Title:	Troubleshooting Diesel Exhaust Fluid (DEF) Headers on Cummins			
Number:	SB_406	Release Date:	12/6/2017	
Revision Number:	12	Revision Date:	07/18/2023	
Chassis Type:	All custom chassis with a 2016 and newer Cummins engine			
Component Description:	DEF Header			
Warranty:	Not Applicable			
Parts:	Not Applicable			
Tools:	Not Applicable

**Supersedes: Bulletin 406 Supersedes bulletins, 425, 426, and 427.**

This latest revision is to address production and service change from optical header 3539748 to ultrasonic header 3584091.

*Figure 2, KUS Ultrasonic Header*

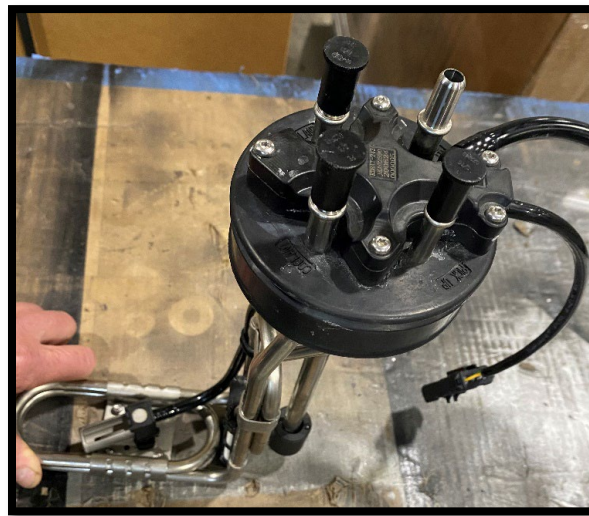
- **PNs 3252987, 3264272, 3280600, 3438479, 3539748, 3584091 (KUS)** Used in production, and service, from July 2023 – date of writing.
  - Part number 3584091 (KUS Ultrasonic) is the most up-to-date header currently being used in production.

- We have received reports of corrosion within the optical quality sensor on part number 3539748 (KUS Optical). This corrosion may contribute to quality sensor voltage and internal error faults (ie – Cummins Fault Codes 1685, 1686, 1715). Part number 3584091 (KUS Ultrasonic) is intended to reduce the frequency of these failures.

- Micro-bubbles within the quality sensing area can cause inaccurate quality readings outside of the acceptable range required by the Cummins ECU. While ultrasonic quality sensors are considered by much of the industry to be more reliable than optical sensors in these conditions, we have received isolated reports of low concentration faults from pre-production versions of part number 3584091 (KUS Ultrasonic).
